Access Compliance Report

Public Rights-of-Way

(Curb Ramps)

Intersection ID: 45883	Main Street: HOMESTEAD_GLEN_BV	Cross Street: BEN_LIVINGSTON_RD	Location: NE
ADA ID: 729DE6BBB2F9	Ramp Type: PerpDiag	Initial Pass/Fail: Fail	Overall Compliance: No
Codes/Mitigation Info/Possible Solution		Field Measurements/Component Compliance	
Severity Score: 8.75

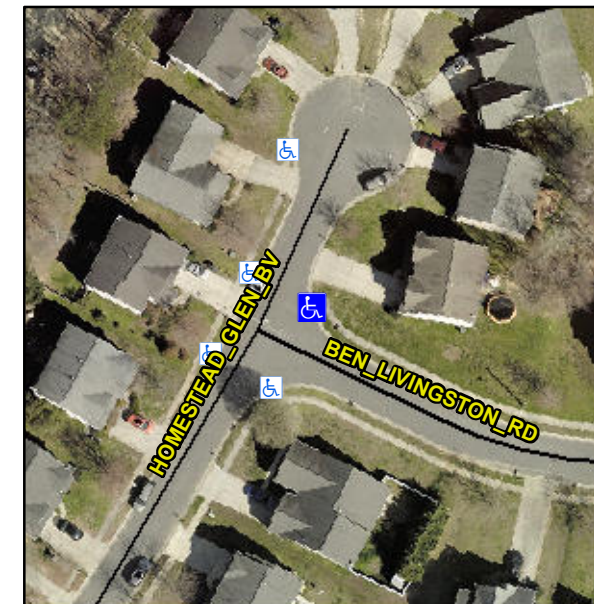
Not Found, R304.5.1

Compliance	Description	Data	Compliance	Description	Data
N/A	Ramp Length (in)	46.0	Yes	Ramp Slope (%)	5.6
No	Ramp Width (in)	45.5	Yes	Ramp XSlope (%)	1.9
N/A	Flare Type LT	N/A	N/A	Flare Type RT	N/A
N/A	Flare Slope LT (%)	N/A	N/A	Flare Slope RT (%)	N/A
N/A	Flare Traversable LT?	N/A	N/A	Flare Traversable RT?	N/A
N/A	Landing Length (in)	N/A	N/A	DWS Provided?	N/A
N/A	Landing Width (in)	N/A	N/A	DWS Contrast?	N/A
N/A	Landing Slope (%)	N/A	N/A	DWS Length (in)	N/A
N/A	Landing X Slope (%)	N/A	N/A	DWS Full Width?	N/A
N/A	Landing Curb? (Y/N)	N/A	N/A	DWS Offset (in)	N/A
N/A	Shared Landing?	N/A			
N/A	Gutter Ponding?	N/A	N/A	Gutter Slope (%)	N/A
N/A	Gutter Lip Ht (in)	N/A	N/A	Gutter X Slope (%)	N/A
N/A	Painted X Walk1?	No	N/A	Painted X Walk2?	No
	X Walk 1 Direction	To NW		X Walk 2 Direction	To SW
N/A	X Walk 1 Width (in)	N/A	N/A	X Walk 2 Width (in)	N/A
	X Walk 1 Slope (%)	2.4		X Walk 2 Slope (%)	1.2
	X Walk 1 X Slope (%)	0.2		X Walk 2 X Slope (%)	0.8

Remove & Replace Curb Ramp With Two New Directional Ramps or Equivalent.
